PLAN AND ZONING COMMISSION MEETING

CITY OF DAVENPORT, IOWA

Case F21-10: Request of Catherine Cartee for a Final Plat of a 2 lot subdivision on 2 acres located at 4837 West Locust Street. [Ward 1]

CARTEE'S 5TH ADDITION

FINAL
PLAT

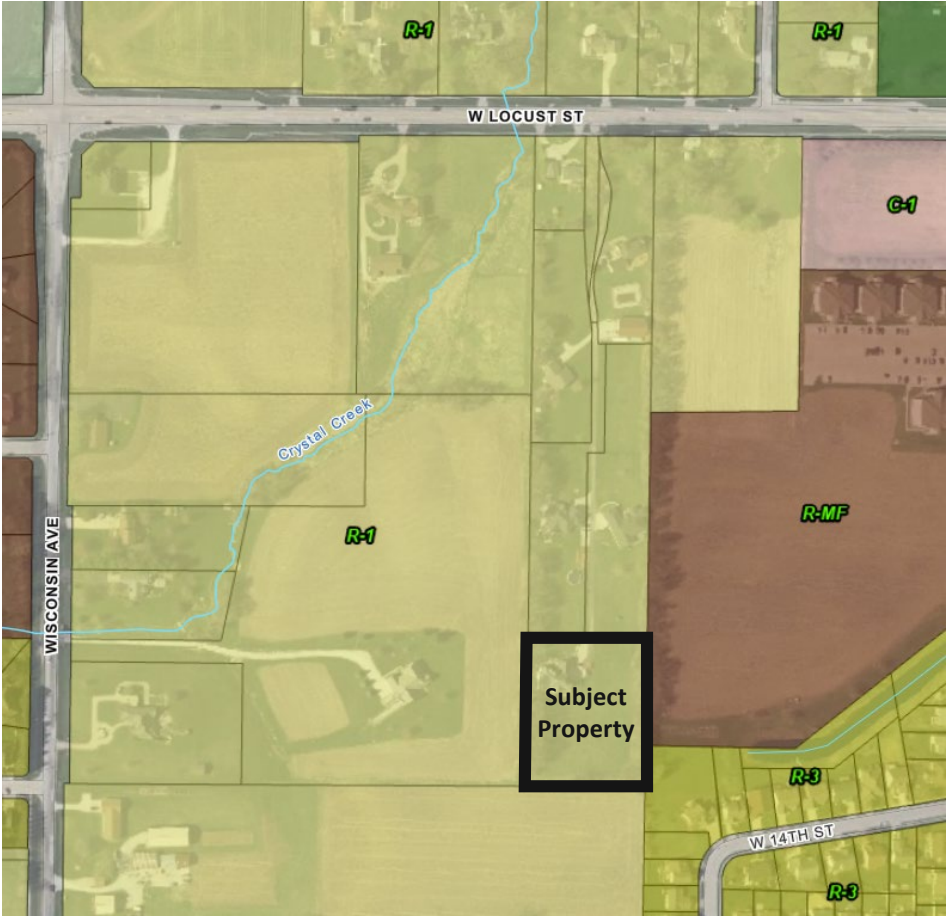
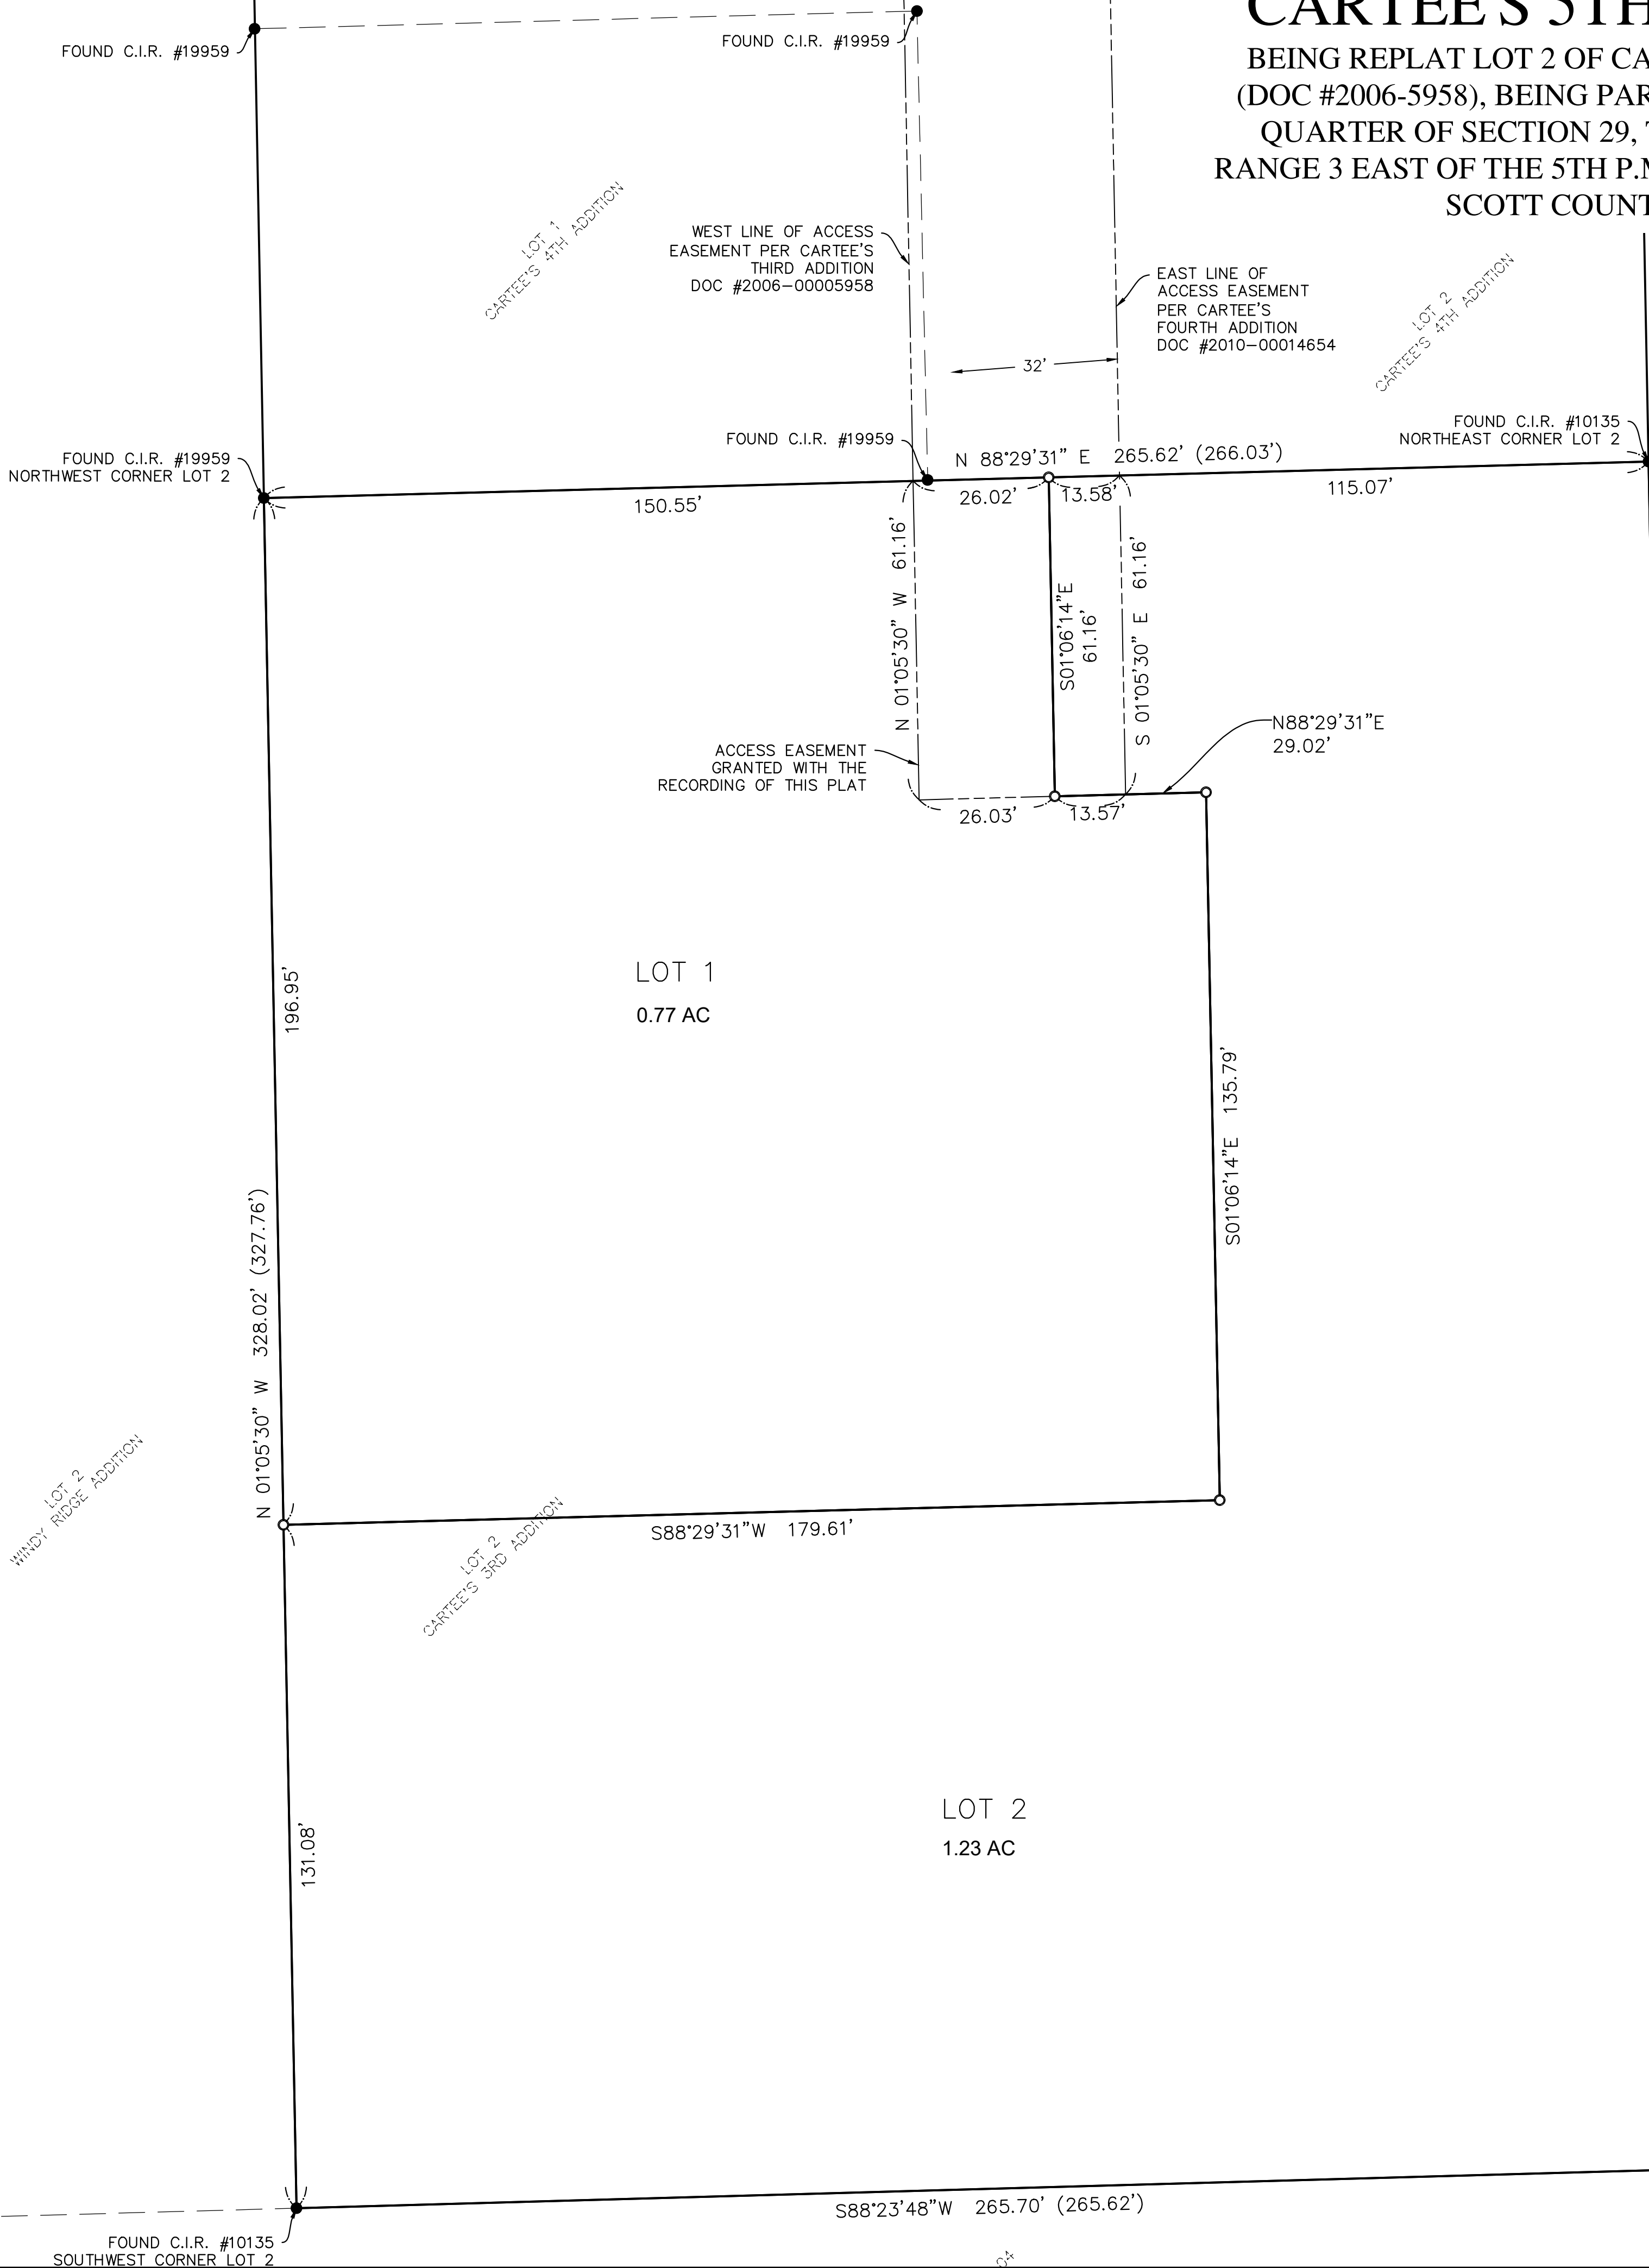
Conditions:

1. That the surveyor signs the plat.
2. That the utility providers sign the plat when their easement needs have been met.
3. Submit an updated access easement and maintenance agreement providing all existing and proposed lots with access rights.
4. Show all existing utility easements.
5. Add a note stating, "Blanket underground easements granted for all primary and secondary electric cables, pad mounted transformers, electric transformers, primary cables, gas service, gas main, utility poles, manholes, water service, sewer lateral, telephone service and cable T.V. service to individual structures and street lights.

- Streets: The proposed plat is located south of West Locust Street, an arterial street. Access to the lots would be by way of an existing driveway. An access easement is required.
- Storm Water: Stormwater regulations will apply in a development with more than 5,000 square feet of impervious surface. This includes houses and driveways.
- Sanitary Sewer: Sanitary sewer service is located to the southwest and is accessible for this development.
- Other Utilities: This is an urban area and normal utility services are available.
- Parks/Open Space: The proposed plat does not impact any existing or planned parks or public open space.
